SUBJECT: Connecting Rod, Crankshafts, Crankcases

DATE: 3/31/66

Units Affected: All XL Engines (except XL-700 and XL-800)

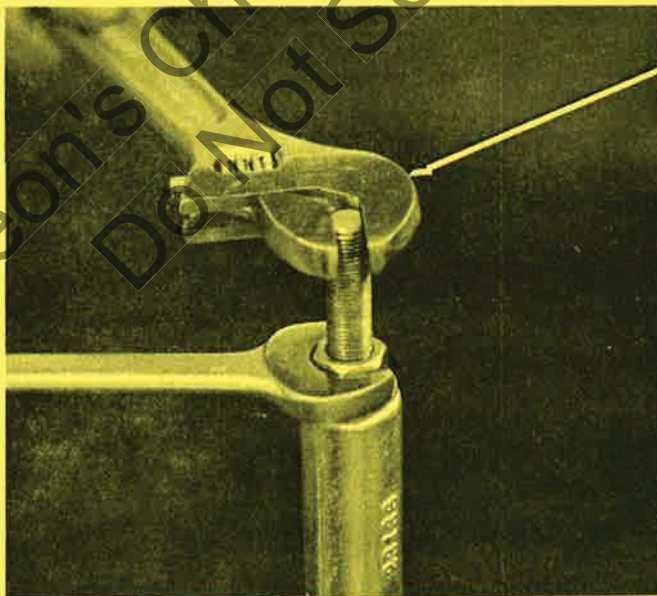
During the installation of ball bearings on shafts, but especially when pulling a shaft with bearing into its housing, it is possible to damage the balls in the bearing unless proper care is exercised:

THE BEARING MUST NOT BE ALLOWED
TO ROTATE WHILE IT IS UNDER PRELOAD
TENSION FROM THE PULLER.

If the bearing is allowed to rotate under preload, the edges of the raceways may "dig" into the balls and may generate shallow grooves on the surface of the balls. These grooves or indentations will make the bearing rough turning and noisy.

To prevent this damage, keep the jackscrew from turning while you turn the jack nut. If the jackscrew you use does not have flats or a hex head on the end, grind or file two flats so that a wrench can be used on the end of the jackscrew as shown in the picture below.

Use this wrench to keep assembly from turning.

Figure 1

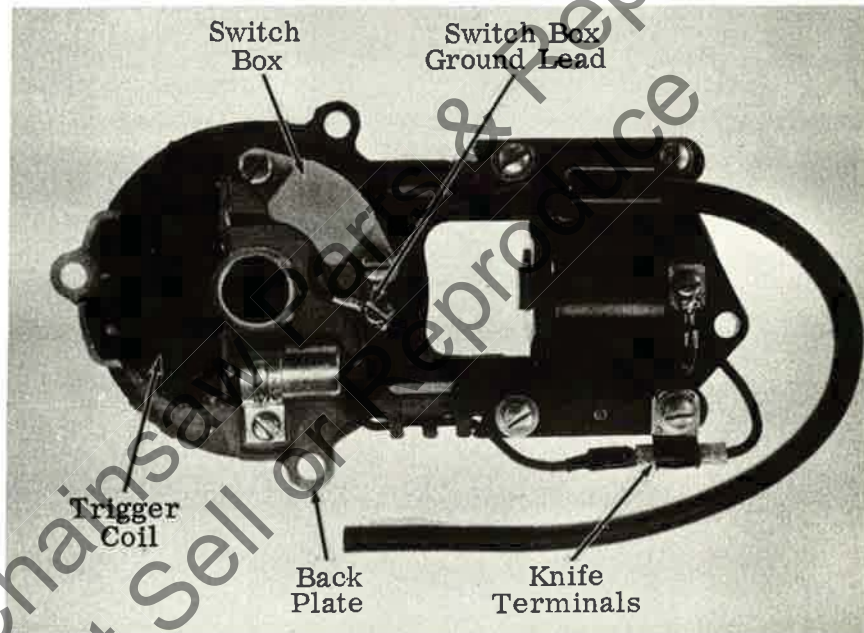
1. Connect the spark plug lead to a test spark plug and crank the engine to check for magneto output. If there is no output, remove the fan housing.
2. Visual Inspection
 - a. Inspect the rotor for physical damage.
 - b. Inspect the stator for broken or frayed wires.
 - c. Check for a short between the coil core and the knife terminals connecting the coil primary lead to the lead from the switch box. All leads should be dressed as shown in Figure 1. All soldered connections should be sound.

Figure 2

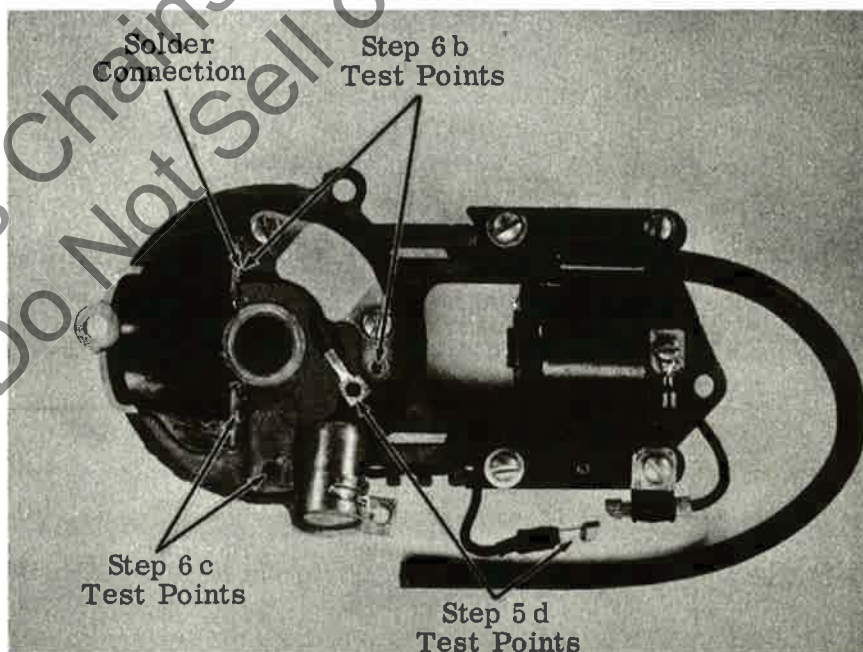
4. If the coil tests satisfactorily, remove the rotor.
5. Switch Box Testing (Figure 2)
 - a. The coil primary lead must remain disconnected from the switch box lead (Step 3) and must be above ground (not touching any part of the back plate) during all testing.
 - b. Remove the condenser mounting screw and hold the condenser above ground with a piece of insulating material.
 - c. Disconnect the switch box ground lead by removing the small screw in the center of the back plate, to the lower right of the switch box.
 - d. Perform the following tests with an ohmmeter by connecting:

6. Trigger Coil Testing (Figure 2)
 - a. Two different types of trigger coils are in use with the breakerless magneto, but both are tested by the same procedures. Magnetos with 700 turn trigger coils are
